PROJECT: **CARRIAGE MEADOWS SOUTH**  
 FONTAINE BLVD -CARRIAGE MEADOWS DR.  
 EL PASO COUNTY, COLORADO

**GENERAL NOTES**  
**STREET AND STORM SEWER**

DATE: JUNE 20, 2017  
 PROJECT NO. 100.030  
 SHEET NUMBER **C1.2**  
 TOTAL SHEETS: **39**

**TYPICAL SECTION 80' R.O.W.  
RESIDENTIAL URBAN COLLECTOR**  
NOT TO SCALE

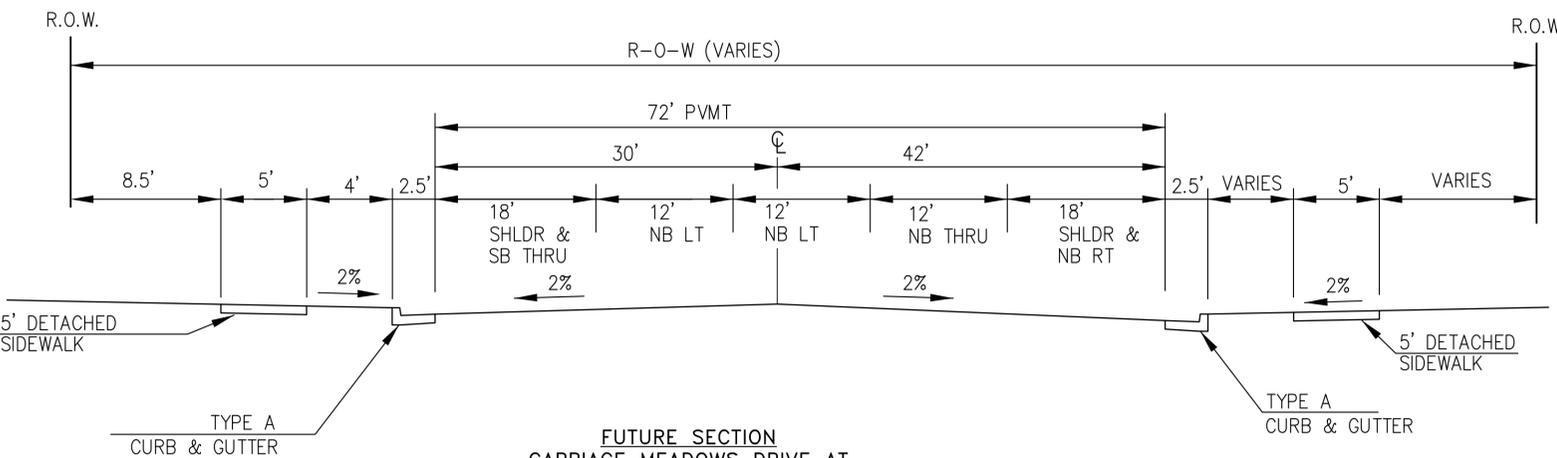
This should read "El  
Paso County PCD  
Engineering" (there  
should not be the  
word and).

**SIGNING AND STRIPING PLAN**

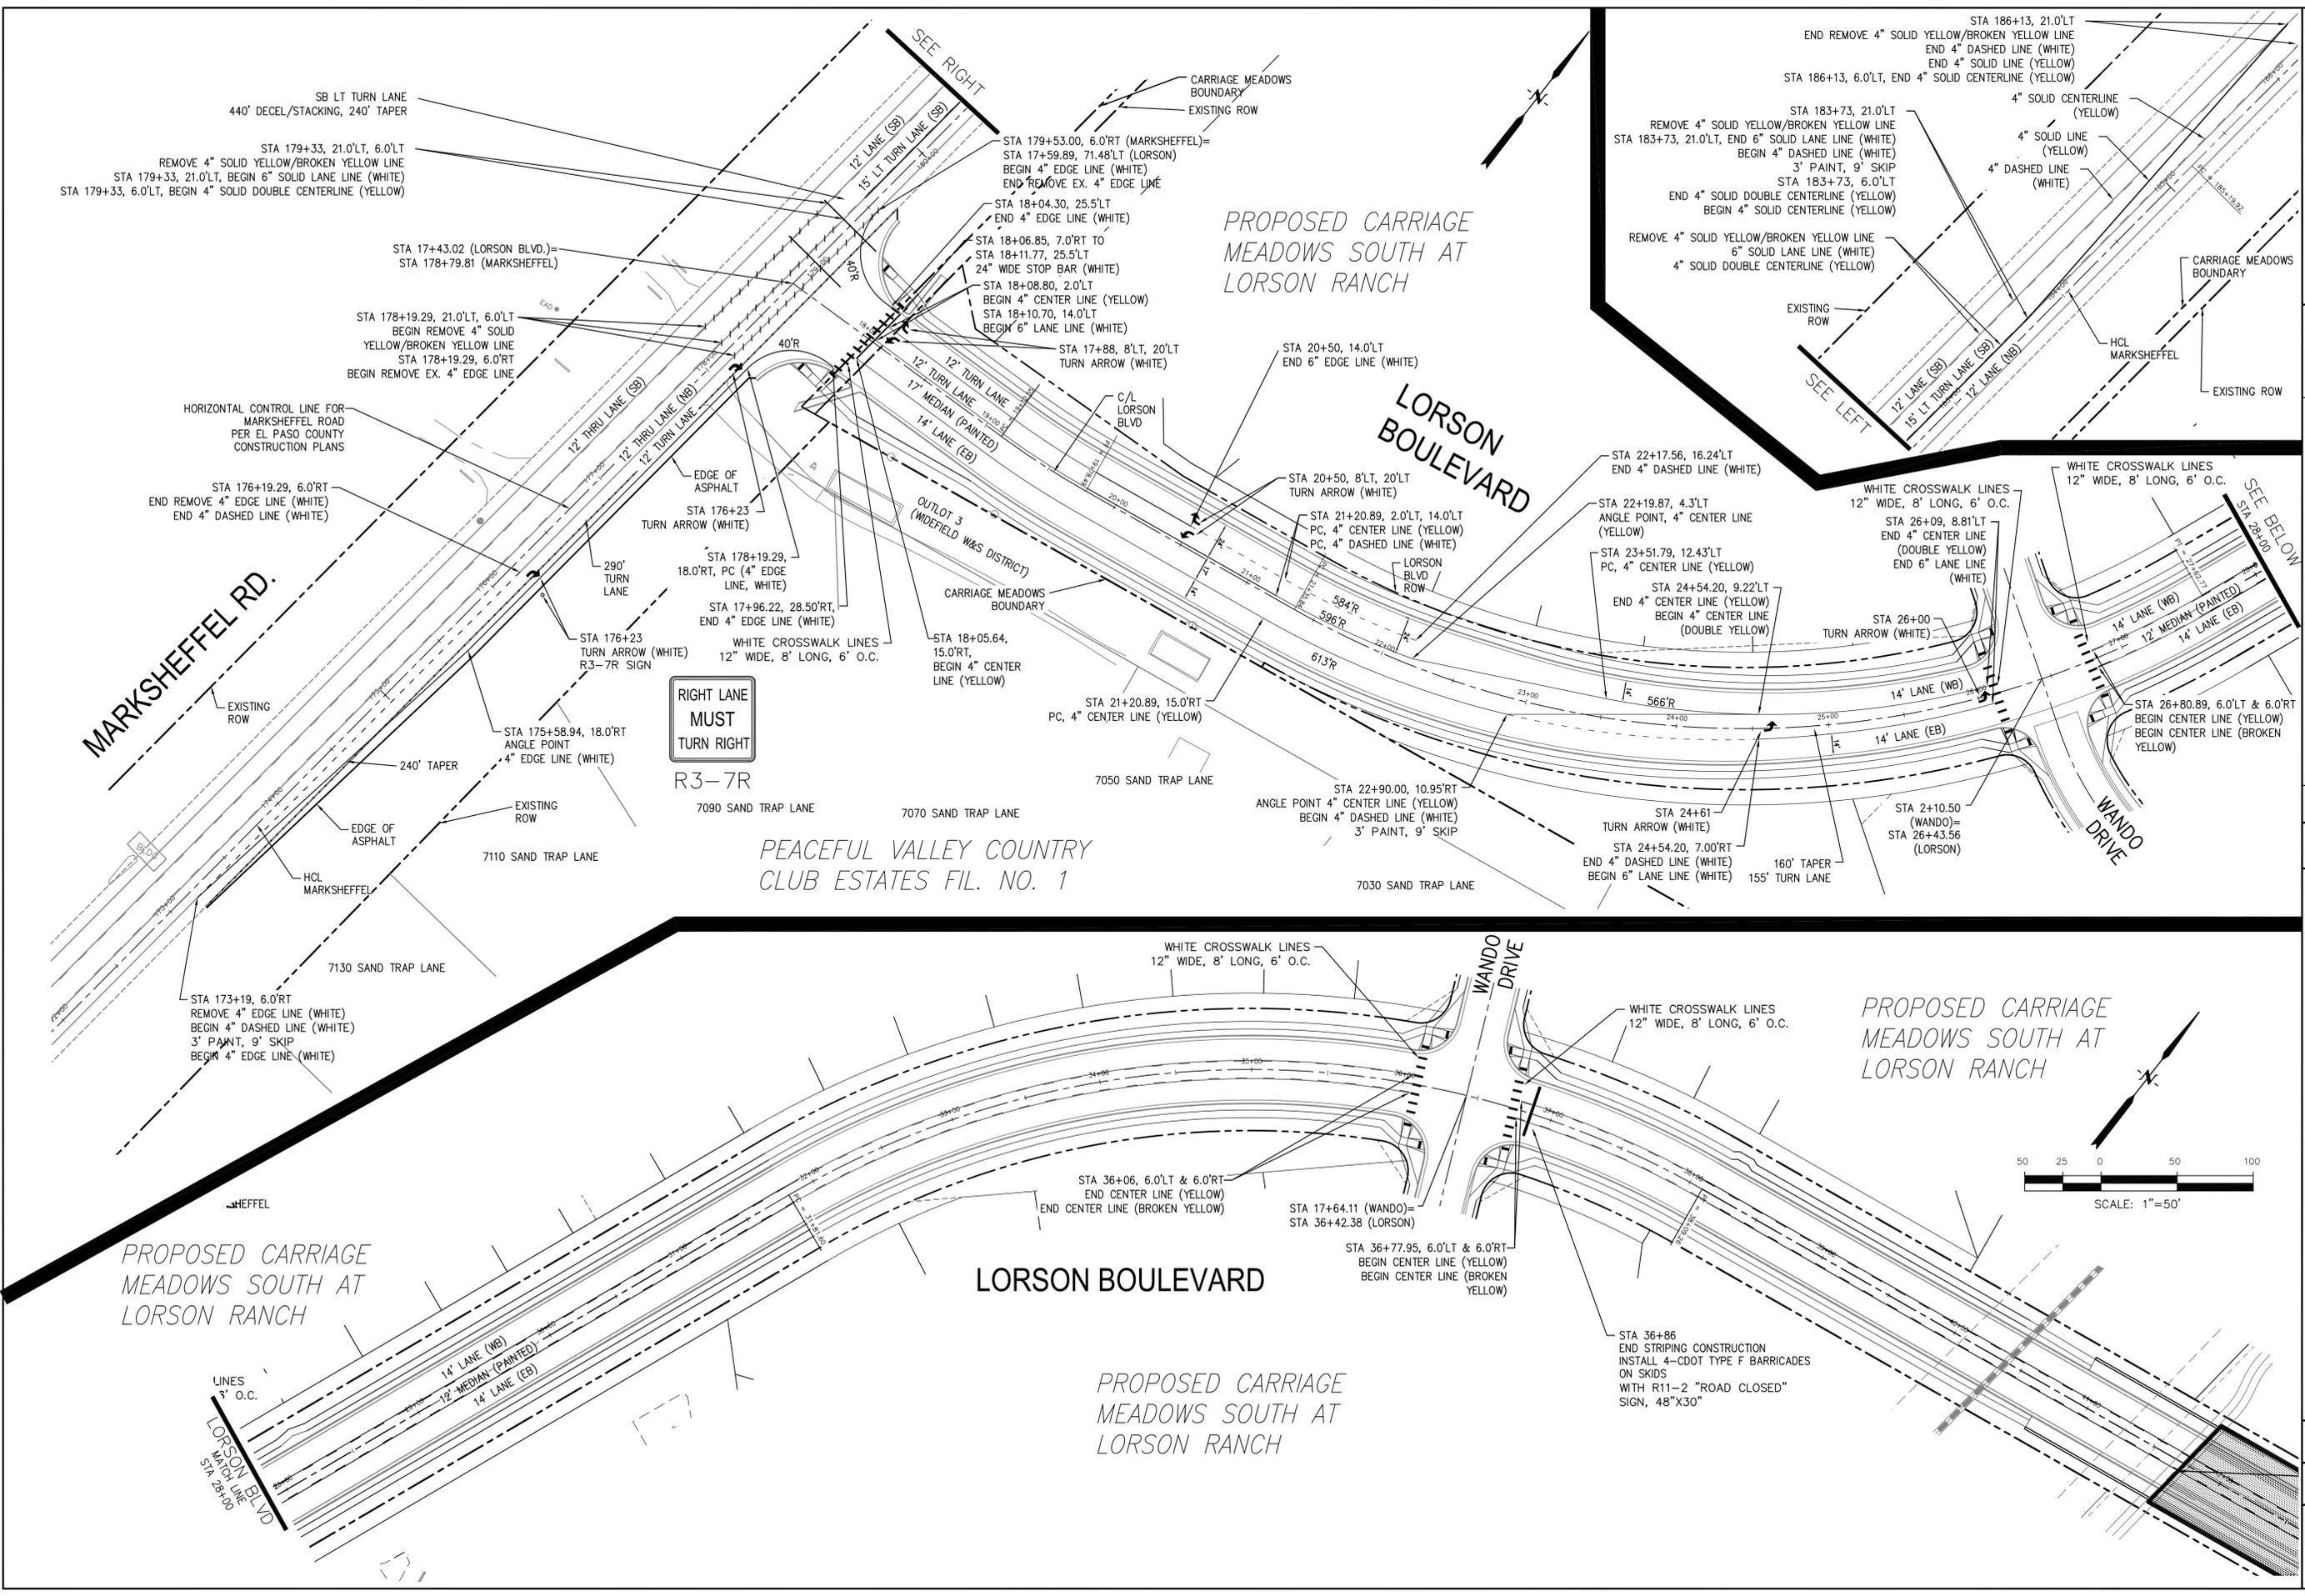
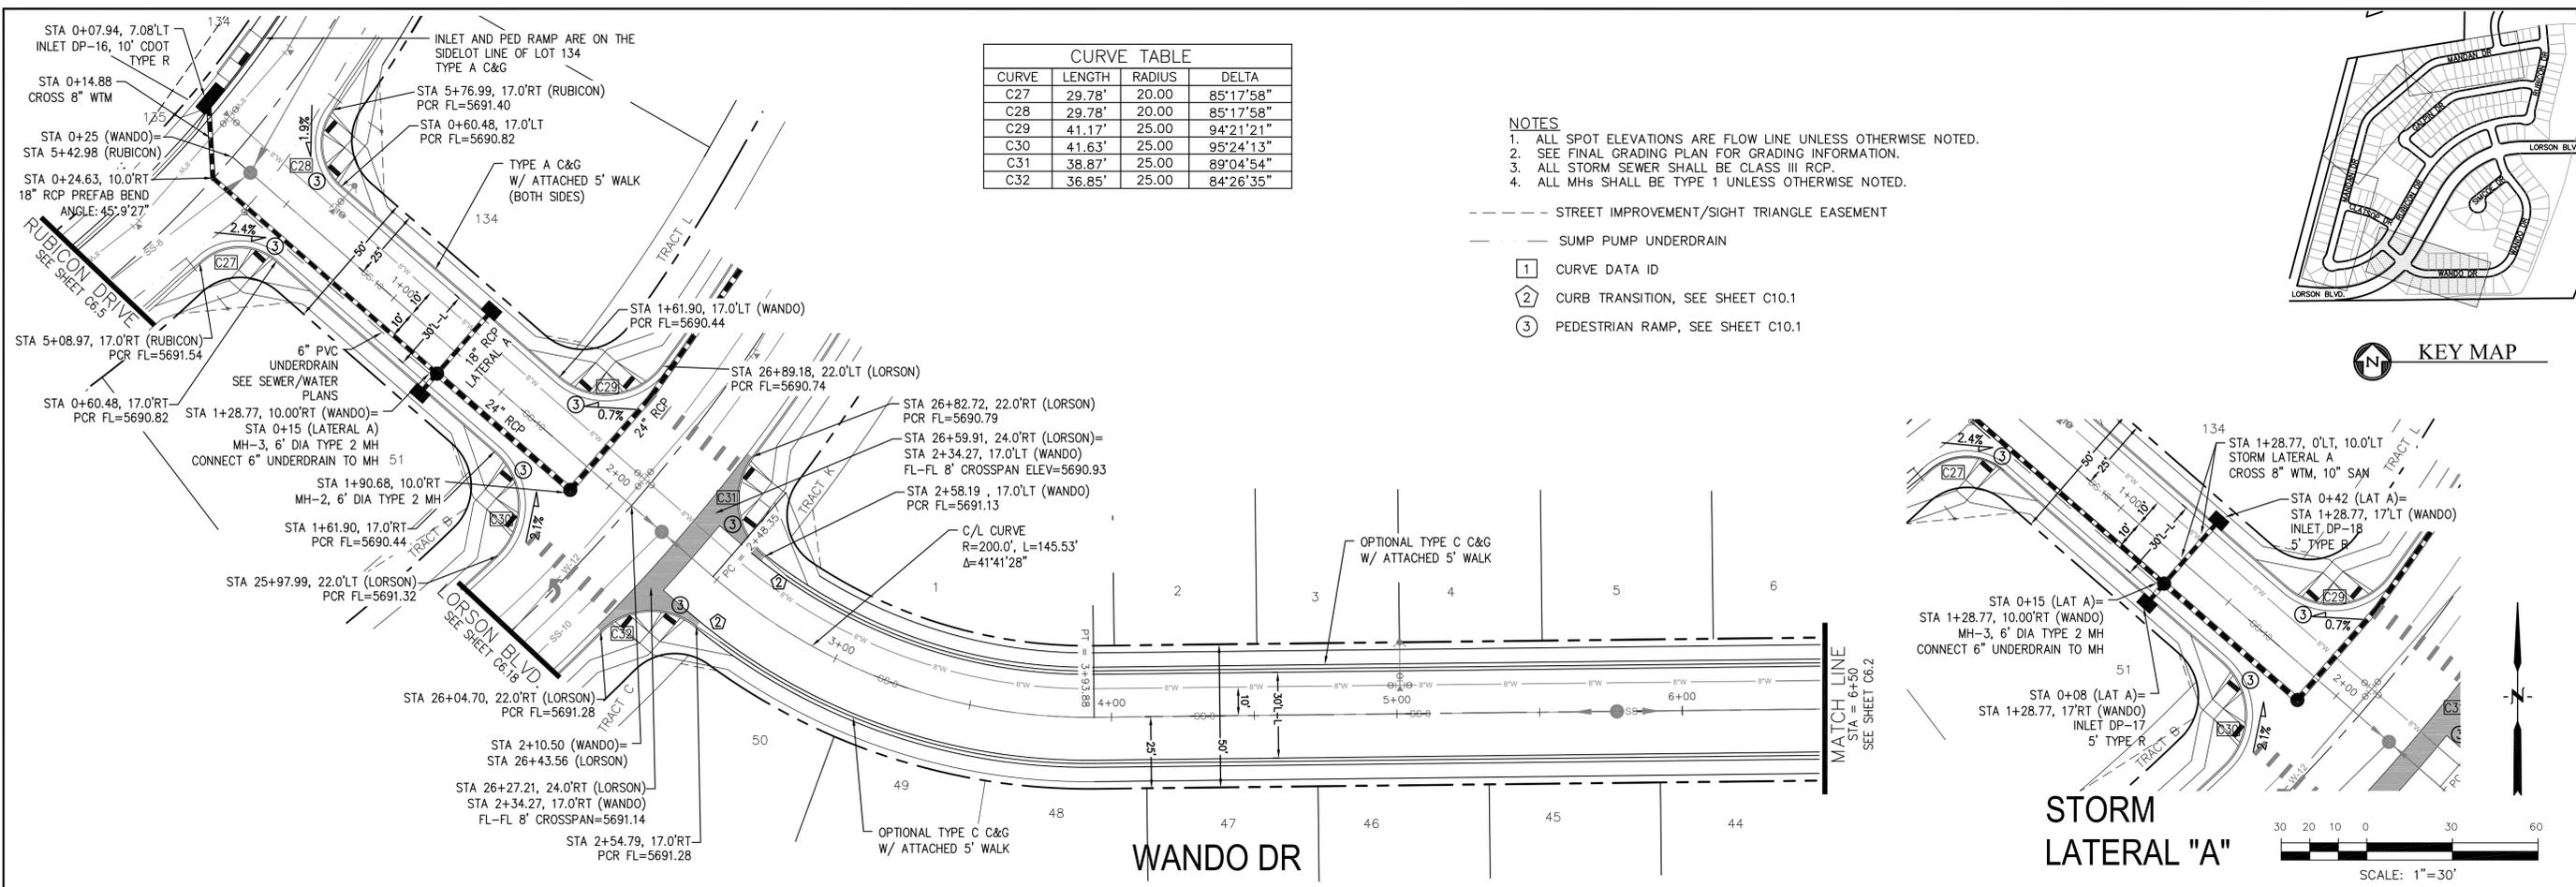
In general all signs that are on Lorson or MS need to be larger. Please call out all signs that need to be 36" in place of 30" typical all signs on both streets.
